**Optimization Evaluation
General Motors Former AC Rochester Facility
Sioux City, Iowa**

Report of the Optimization Evaluation
Site Visit Conducted at the General Motors Former AC Rochester Facility
on June 21, 2011

Final Report

Figure 2
Well Locations Map
GM/AC Site
Sioux City, Iowa

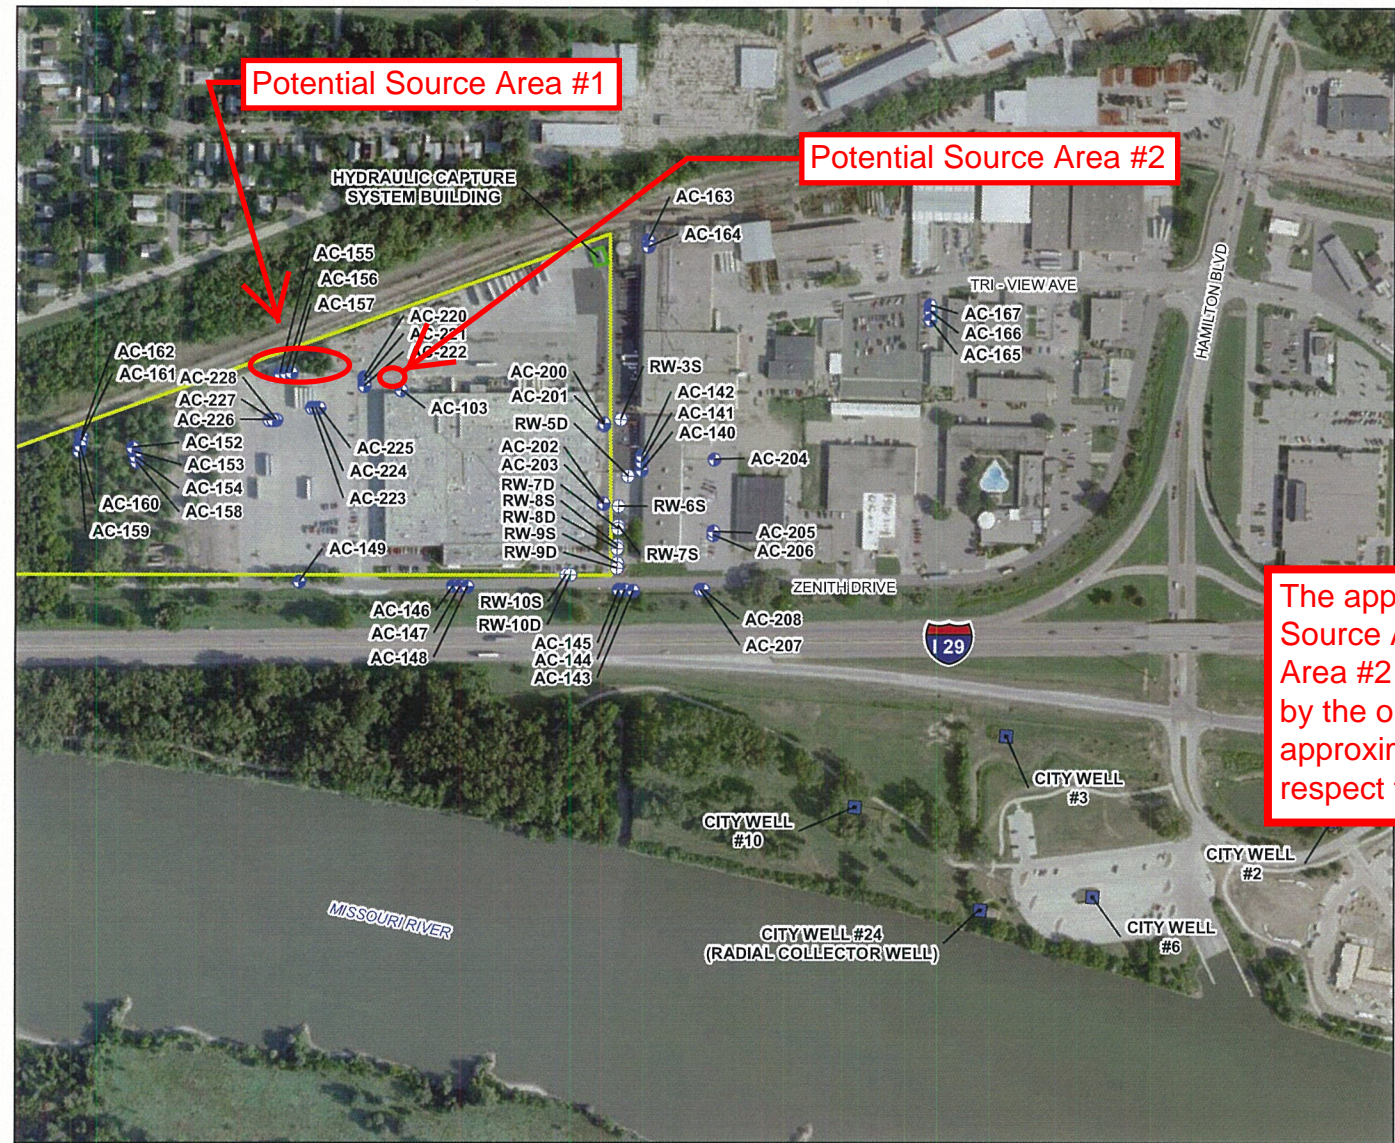
The shallow groundwater CVOC concentrations indicate that the main contamination source area is Potential Area #1 in the north end of the parking lot to the west of the main site building (see last figure of Attachment A). No specific infrastructure in this area (e.g., tanks) was present in this area to suggest a cause for the release. One potential explanation could have been dumping, rinsing, or handling of spent solvent containers just to the west of the former propane storage area from where the solvent could have accumulated in the depressed area and infiltrated to shallow groundwater. Once in shallow groundwater, the CVOCs migrated to the east/southeast and to greater depths as they were influenced by pumping from City Well #3 and the other municipal supply wells. Reductive dechlorination of the contamination is occurring (either naturally or partially due to the butane stimulation), but degradation appears to be stalling prior to reaching non-toxic products and overall CVOC concentrations are still high. Residual contamination in the unsaturated and saturated soil of the source area continue to result in total CVOC detections above 20,000 µg/L in the source area after more than 13 years of sampling. Under current conditions and remedial activities, source area concentrations and the downgradient plume will likely not reach cleanup goals for many decades.

Potential Source Area #1, which is located at the north end of the parking lot on the west side of the facility building (see last figure in Attachment A), has the highest CVOC concentrations in shallow (25 feet to 32 feet bgs) groundwater. Total VOC concentrations exceeded 15,000 µg/L within an area bounded by monitoring wells AC-155, AC-223 and AC-226 in February 2011. These three monitoring wells form a triangular area with approximately 150-foot long sides. The nearest shallow wells to this triangle are about 150 feet east (AC-220), 300 feet west (AC-152), and 400 feet south (AC-149). The north side is limited by railroad tracks and the steep bluff within 100 feet. Total CVOC concentrations were less than 70 µg/L in monitoring well AC-152 and not detected (ND) in monitoring well AC-149. Total CVOC concentrations were detected at 767 µg/L in monitoring well AC-220 and greater than 2,500 µg/L in monitoring well AC-221. Monitoring well AC-220 is to the east (downgradient) of the triangle, and monitoring well AC-221 is the next deeper well at the same location (screened from 41 to 46 feet bgs). The source area extent would need to be better characterized for remediation.

1,1-DCA in City Well #3

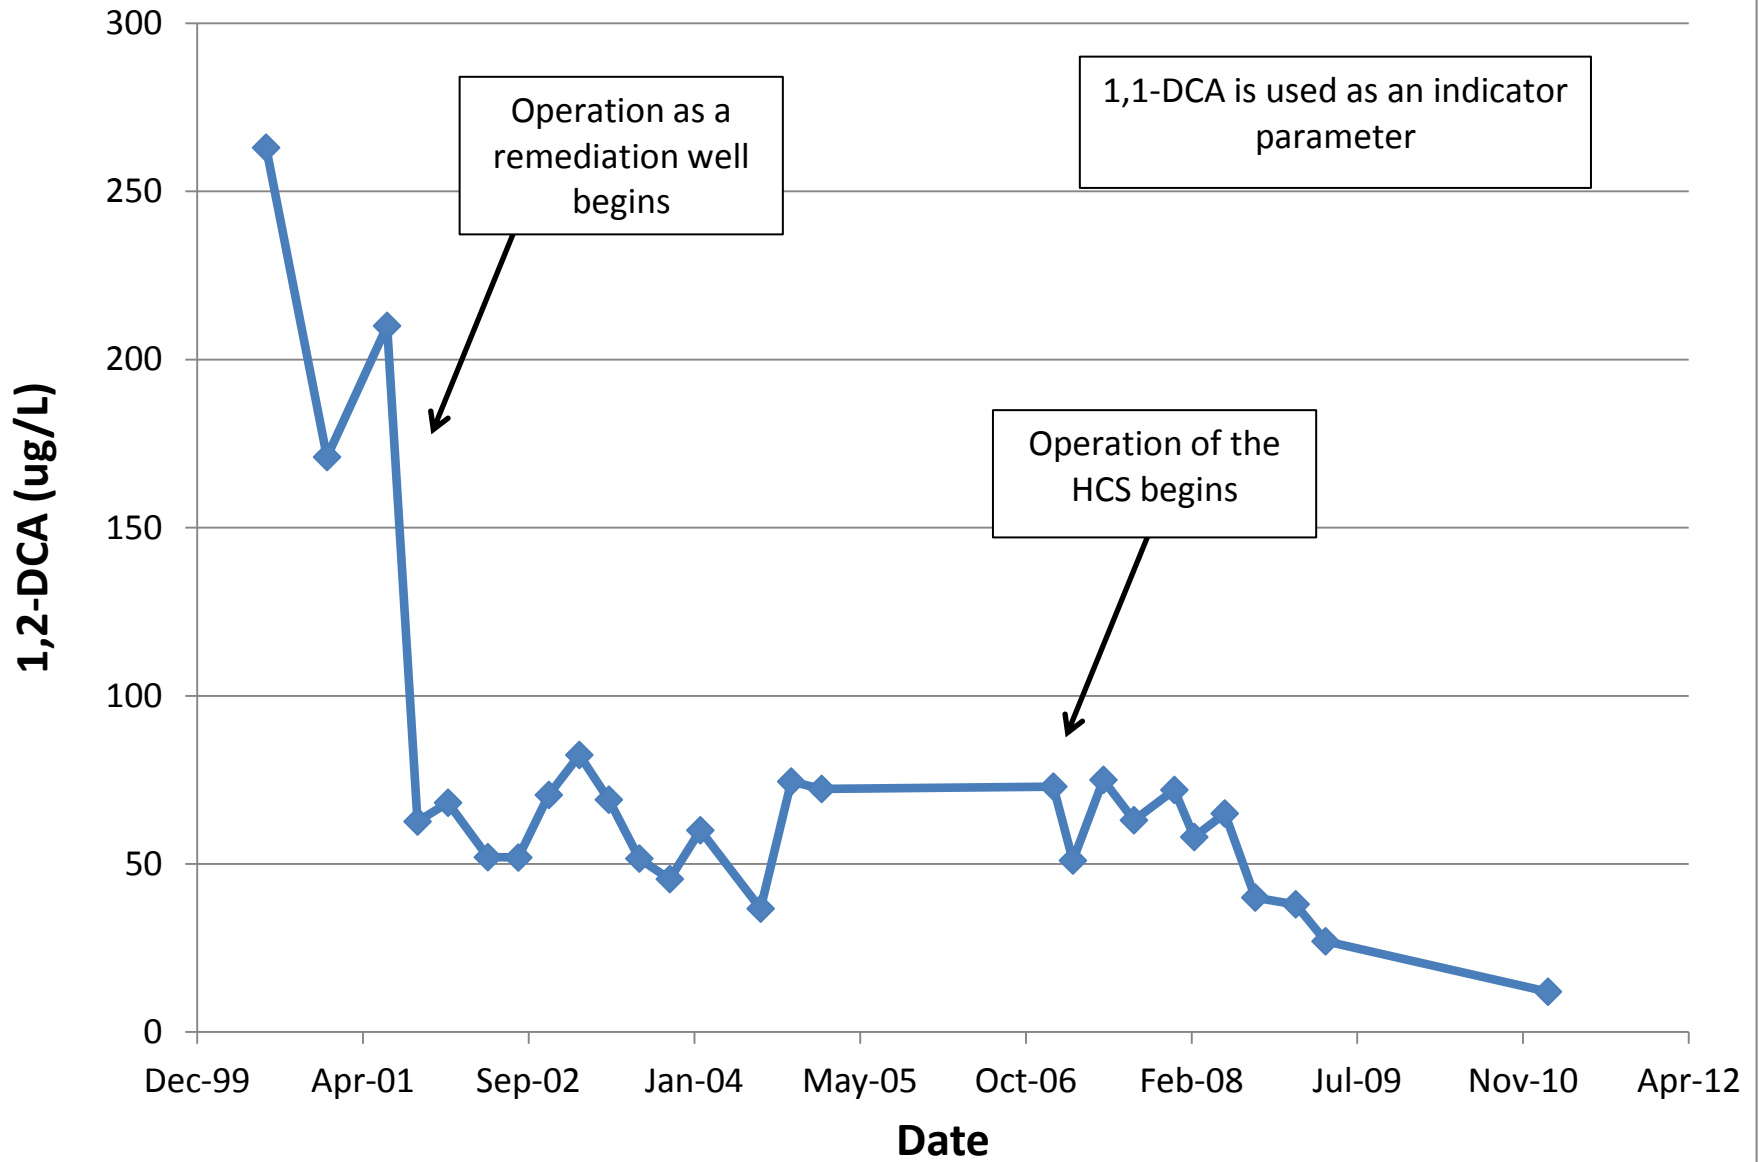
At an assumed rate of 300 gpm (consistent with recovery rates in 2008 and 2009) and a total CVOC concentration of 26 µg/L (February 2011 data), City Well #3 would remove 34.2 pounds per year if it were to continue operating.

Given that the discharge agreement is limited to City Well #3 and that a similar agreement would not likely be available for a new well, the optimization team strongly recommends using City Well #3 instead of a new well to provide the same function.

Model 300L

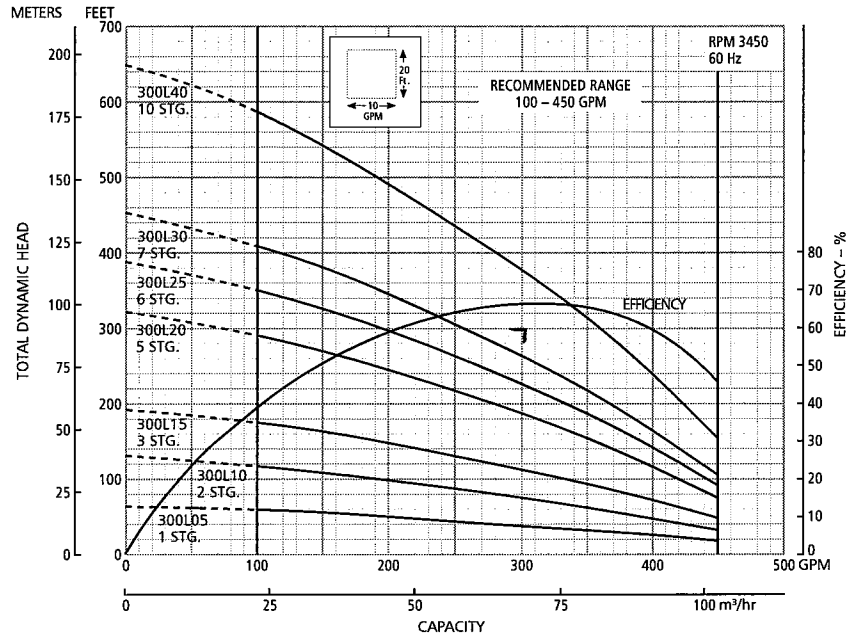
If the site team decides to operate the well, the site team could consider using a smaller pump. A 40 HP Gould pump Model 300L40 (Attachment E) would provide the same flow at an adequate pressure for the use of the well as part of the containment system. Operating this pump (assuming 75% motor efficiency and 100% load) would require approximately 350,000 kWh per year. With an electricity rate of \$0.05 per kWh, this would cost \$17,500 per year. Even if a higher rate of \$0.075 per kWh were assessed, the cost would be approximately \$26,000 per year. The cost savings of operating this smaller pump compared to the current pump (or equivalent replacement) is approximately \$48,000 per year assuming an electrical rate of \$0.05 per kWh.
